ALLEGHENY COUNTY SANITARY AUTHORITY

CONTRACT NO. 1729 G, E, H, P

EAST HEADWORKS

ADDENDUM NO. 3

FULL-DEPTH CONCRETE CURB 9
NTS

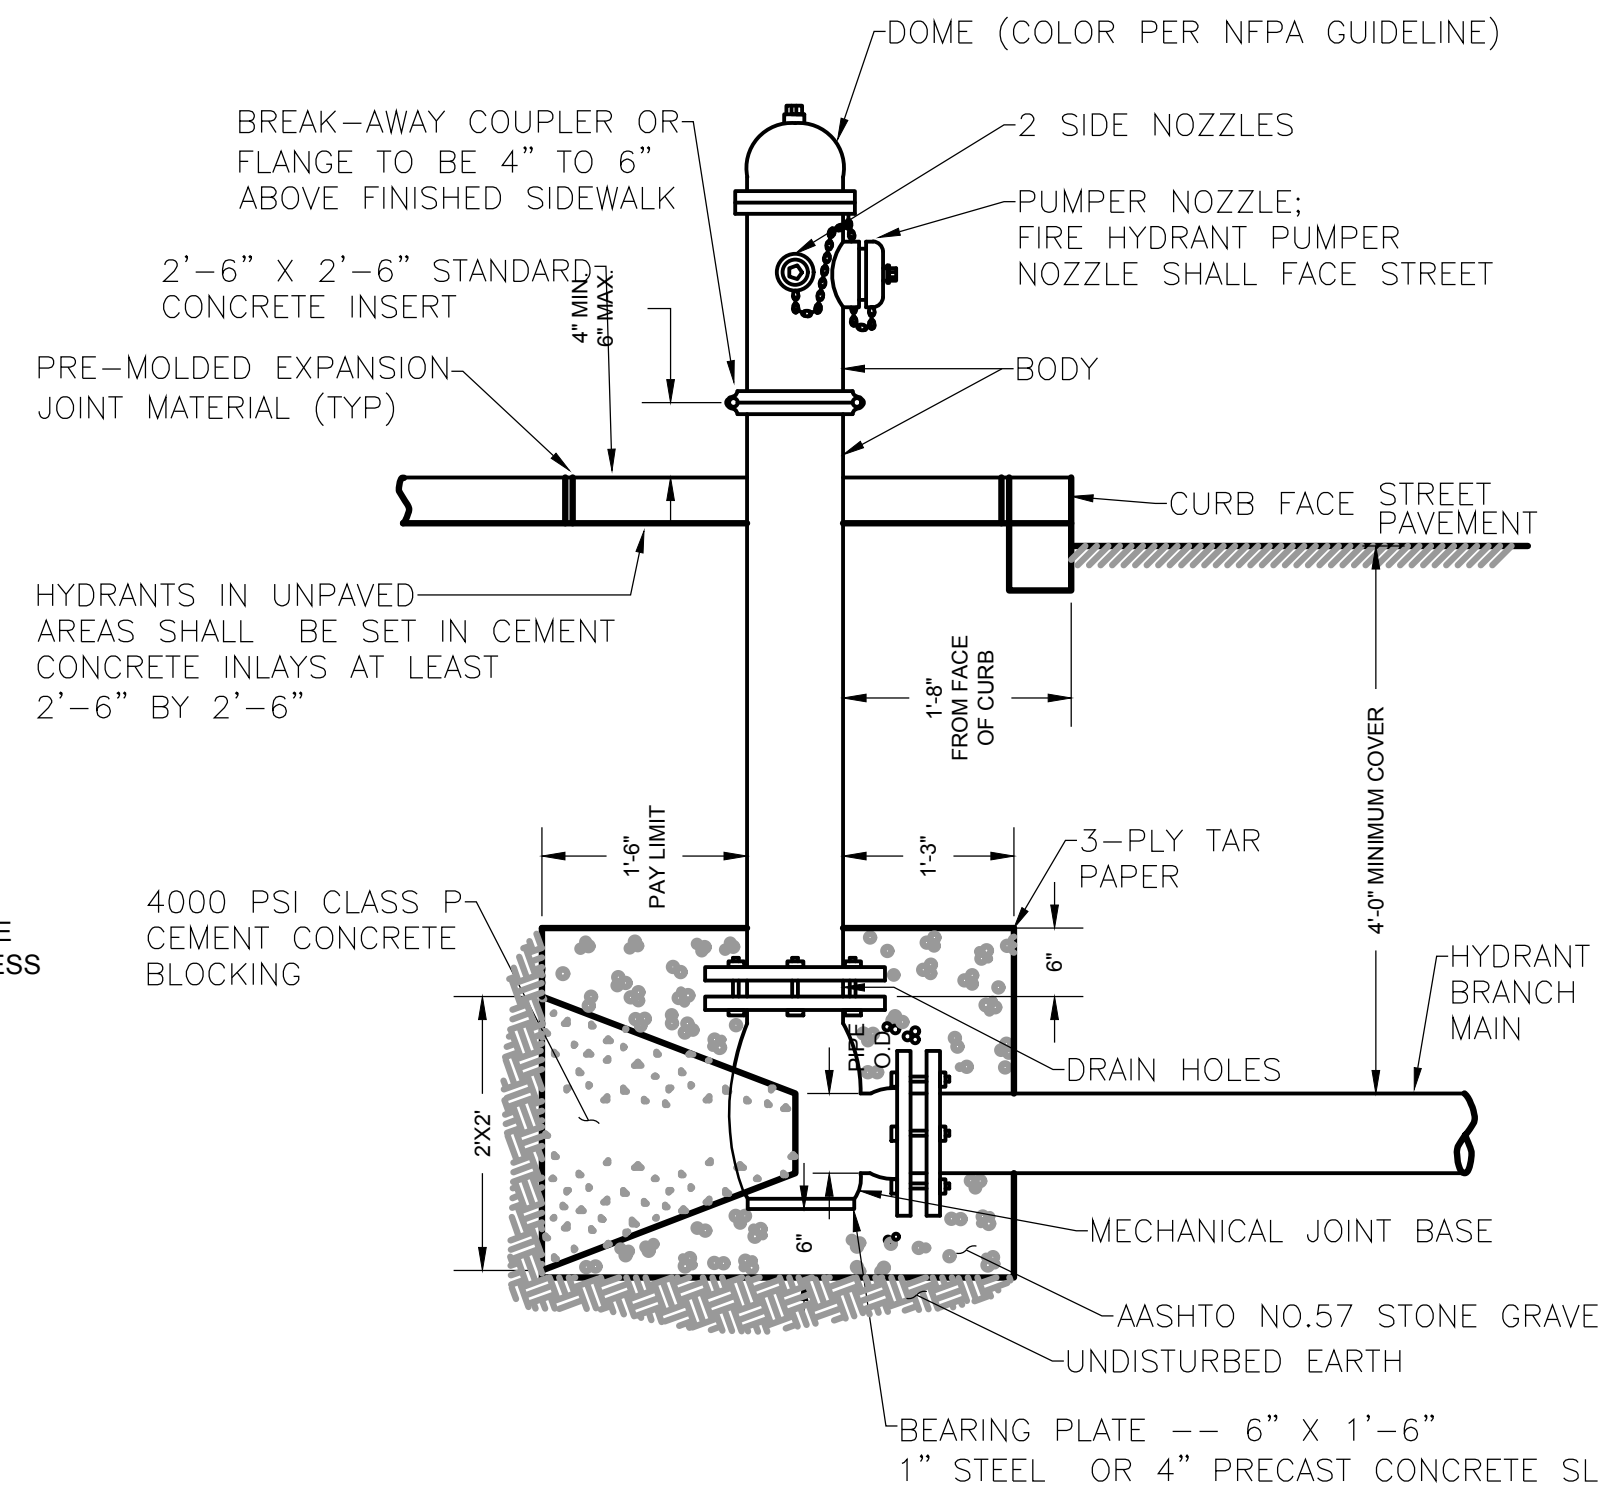
2. Drawing CD-10

- a) DELETE this drawing and REPLACE with the attached drawing CD-10.
